2 SITE CHARACTERISTICS

2.5 Geology, Seismology, and Geotechnical Engineering

PSEG Site early site permit (ESP) application, Section 2.5, "Geology, Seismology, and Geotechnical Information," of the Site Safety Analysis Report (SSAR), Revision 3, contains information on geologic, seismic, and geotechnical characteristics of the proposed ESP Site. The applicant (PSEG) followed guidance in Regulatory Guide (RG) 1.208, "A Performance Based Approach to Define Site-Specific Earthquake Ground Motion," to define the following four zones around the site and conducted investigations in those zones that became progressively more detailed passing from site region to site location:

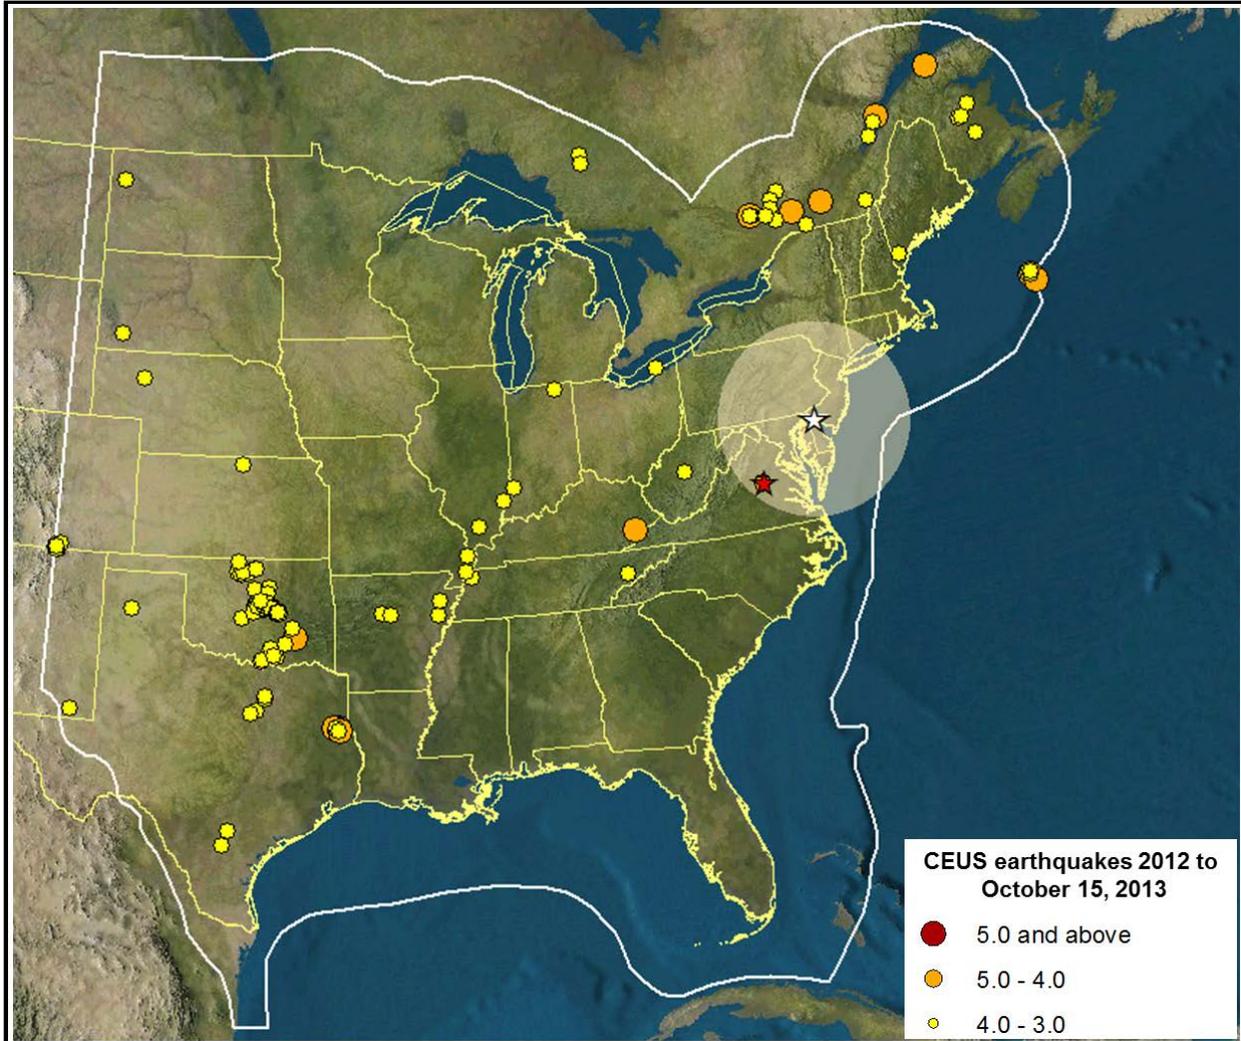
As part of its confirmatory analysis, the staff developed a supplementary earthquake catalog covering the CEUS region from 2009 through October 15, 2013. The staff used this earthquake catalog to confirm the applicant's updated catalog and to determine whether there are new earthquakes in the CEUS region since the submission of the PSEG ESP application that might impact either the maximum magnitude distribution of the seismic sources identified in the NUREG-2115 model or the earthquake recurrence rates calculated for each of the seismic sources used in the PSEG Site PSHA study. The staff used the United States Geological Survey (USGS) Advanced National Seismic Network earthquake catalog (ANSS)² for this analysis. The staff searched for earthquakes with magnitudes 3.0 and above within the time window covering 2009 through October 15, 2013, throughout the CEUS as defined by NUREG-2115. The staff's supplementary earthquake catalog confirmed that the applicant adequately updated its catalog from 2009 through 2011. In addition, the staff's catalog showed that there are 173 earthquakes in the CEUS region (Figure 2.5.2-6 of this report) that occurred between 2012 and October 15, 2013. None of these earthquakes have moment magnitudes (**M**) equal to or greater than **M**5.0. The staff identified 15 earthquakes in the range between **M**4.0 and 4.9 distributed over the CEUS region. The majority of the earthquakes (158 of the 173) in the updated catalog are small magnitude earthquakes (**M** < 4.0). Therefore, the staff concludes from its confirmatory analysis that the earthquakes in the staff's supplementary catalog are located within identified active CEUS seismic regions and do not add any new information to the catalog used by the applicant.

However, due to the large magnitude of the **M5.8** Mineral, VA earthquake, the staff inquired further and issued to the applicant two RAIs regarding the impact of the 2011, Mineral, VA earthquake on the PSEG Site seismic hazard analysis. Specifically, in RAI 71, Question 02.05.02-11, the staff requested that the applicant assess the impact of the 2011, Mineral, VA earthquake on the PSEG Site seismic hazard analysis regarding potential changes in earthquake recurrence rates in the vicinity of the earthquake's hypocenter, and their potential impacts on the site's calculated hazard. In an August 29, 2013, response to RAI 71, Question 2.5.2-11, the applicant performed sensitivity calculations to demonstrate that using updated earthquake recurrence rate parameters, to include the **M5.8** Mineral, VA earthquake, had no significant effect on the seismic hazard at the PSEG Site. The applicant performed the sensitivity calculations using the four NUREG-2115 seismic source zones (ECC-AM, MESE-N, MESE-W and STUDY-R) that host the **M5.8** Mineral, VA earthquake. The applicant compared calculations of the mean annual earthquake recurrence rate per degrees squared (for magnitudes greater than 5) and the b-values for the three NUREG-2115 magnitude weighting cases for the four source zones. The applicant concluded that trends in b-values and recurrence rates in the comparisons showed little difference around the **M5.8** Mineral, VA earthquake. Additionally, the applicant compared its original calculations of mean background hazard and mean total hazard at the PSEG Site for 1, 10, and 100 Hz (PGA) with those calculations including the **M5.8** Mineral, VA earthquake. In the August 29, 2013, response to RAI 71, Question 02.05.02-11, the applicant stated:

Based on the staff's review of the applicant's assessment of the **M5.8** Mineral, VA earthquake in the SSAR and in its August 29, 2013, response to RAI 71, Question 02.05.02-11, the staff concludes that the effect of the **M5.8** Mineral, VA earthquake on the mean background hazard and the total mean site hazard at the PSEG Site is negligible and that the applicant's use of the original CEUS-SSC model earthquake recurrence parameters is acceptable. Accordingly, the staff considers RAI 71, Question 02.05.02-11 resolved.

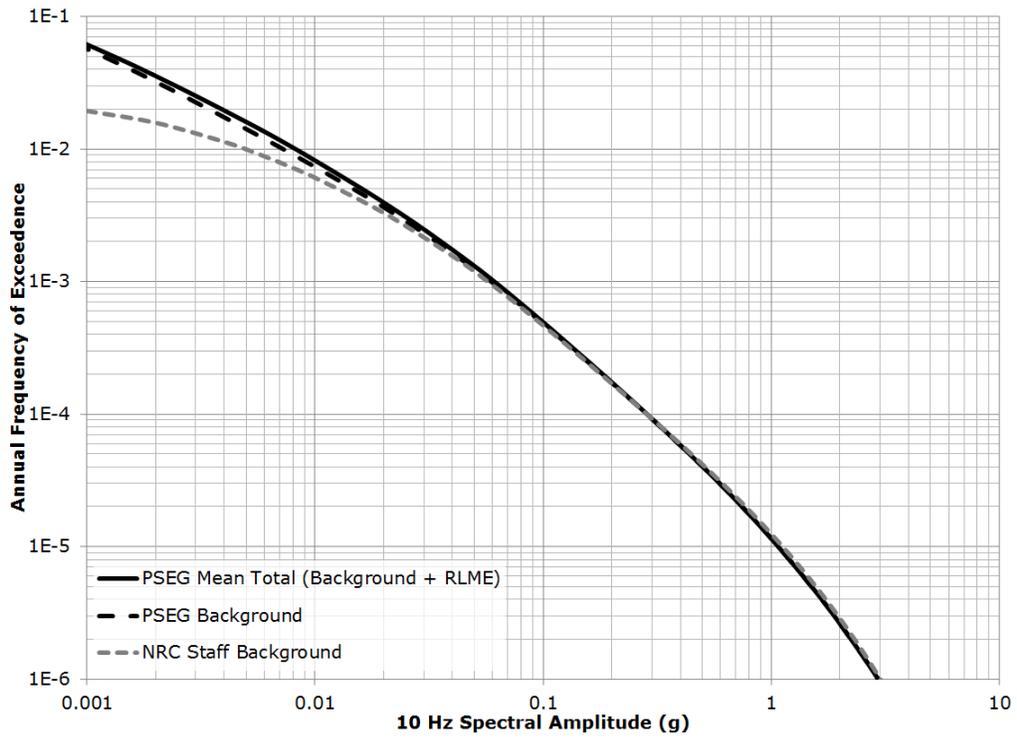
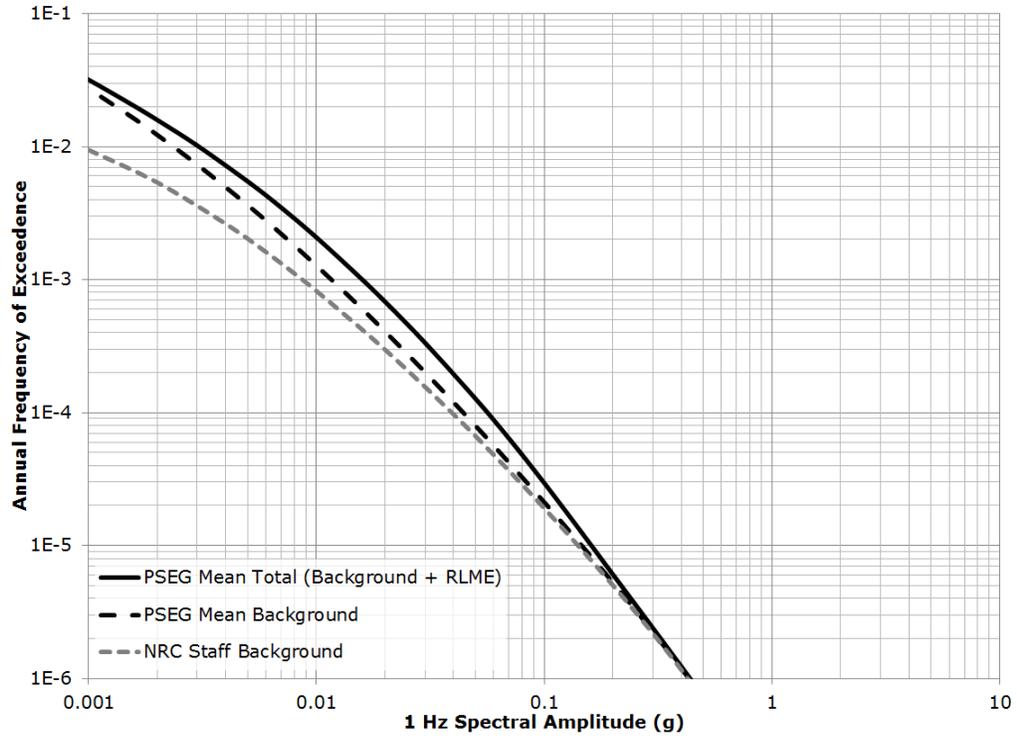
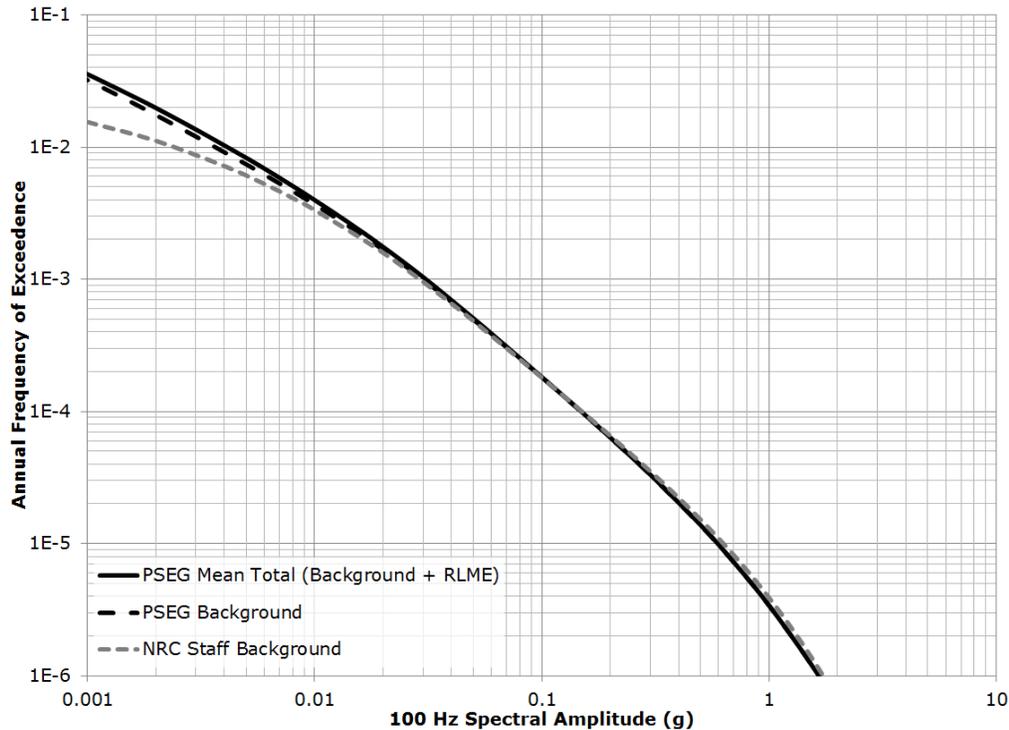
As part of its confirmatory analysis, the staff used the NUREG-2115 CEUS-SSC model background (distributed seismicity) sources and independently calculated the seismic hazard curves at the PSEG Site for all seven ground motion frequencies defined in the EPRI (2004, 2006) ground motion prediction models. The staff's confirmatory calculations did not include the RLME sources. These sources exist at distances beyond 800 km (500 mi) from the PSEG Site and are expected to contribute only at low frequencies such as 0.5 and 1 Hz. From the NUREG-2115 seismic source model, the staff first selected all background seismic sources that are within the 320 km (200 mi) the site region. For those seismic sources which are partly within the 320 km (200 mi) site region, but with boundaries extending beyond the site region, the staff used a distance cut off of 500 km (312 mi). Beyond that distance, their hazard contributions will be negligible. Figure 2.5.2-7 of this report shows the staff's results as compared to the applicant's for PGA and ground motion frequencies of 10 and 1 Hz. The staff's confirmatory calculations show that for the annual frequency of exceedances of 10^{-4} , 10^{-5} , and 10^{-6} , the staff's seismic hazard curves are in good agreement with the applicant's background seismic hazard curves. The difference observed between the background seismic source hazard curves and the total seismic hazard curve at 1Hz shown in Figure 2.5.2-7 of this report is attributed to the contribution of the RLME seismic sources at large distances. As shown in SSAR Figures 2.5.2-25 through 2.5.2-30, at low frequencies, such as 2.5, 1, and 0.5 Hz, distant RLME sources contribute to the hazard at the site. In contrast, at high frequencies only local sources contribute to the hazard. Based on this analysis, the staff concludes the applicant adequately characterized the mean seismic hazard at the PSEG Site.

Figure 2.5.2-8 Comparisons of the staff's site response amplification function with the amplification function determined by the PSEG applicant for the 10-5 annual frequency of exceedance

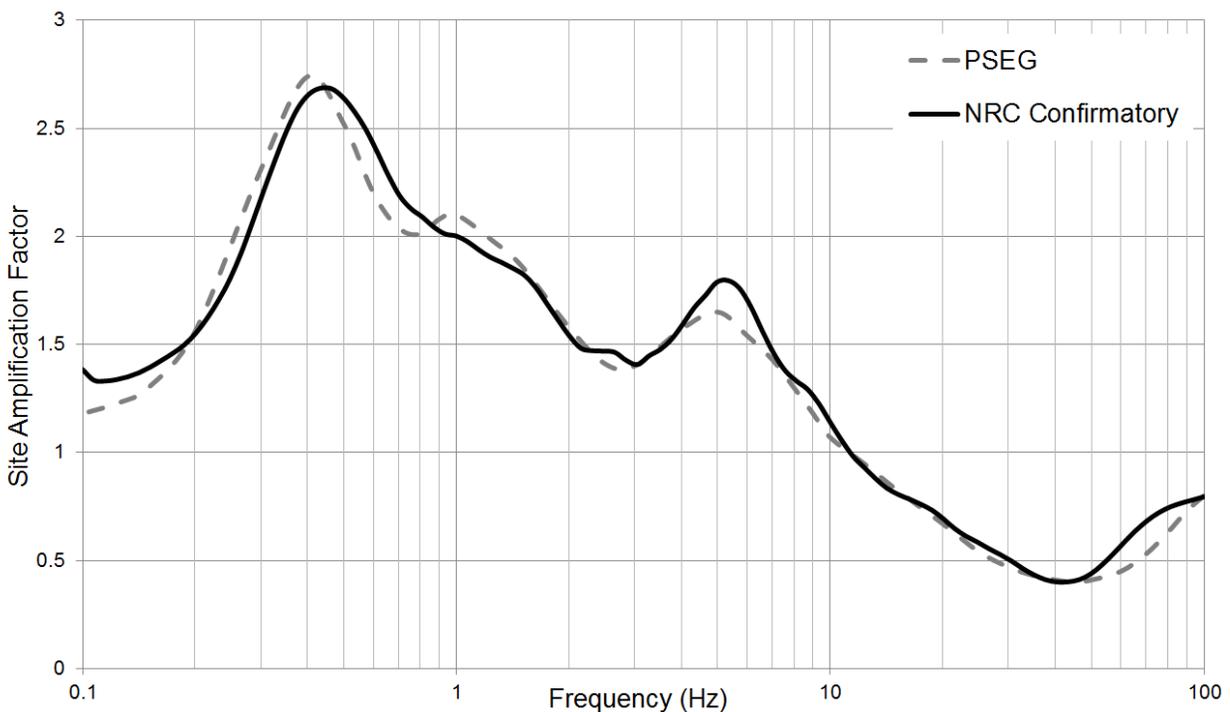
To determine the adequacy of the applicant's site response calculations, the staff performed its own confirmatory site response calculations. As input, the staff used the static and dynamic soil properties provided in SSAR Section 2.5.4. To represent the input rock motions, the staff used the applicant's low- and high-frequency 10^{-5} rock spectra. The staff performed its site response calculations using the Strata software (Kottke and Rathje 2008). The staff's site amplification function results are compared with the applicant's results in Figure 2.5.2-8 of this report, which shows that the staff's calculation is similar to the applicant's site amplification factor across the frequency range typically important for engineering purposes (i.e., 0.5 to 10 Hz) and they are within the limits of uncertainties expected from these calculations. Based on this assessment, the staff concludes that the applicant's site response calculations adequately characterize the site effects at the PSEG Site.
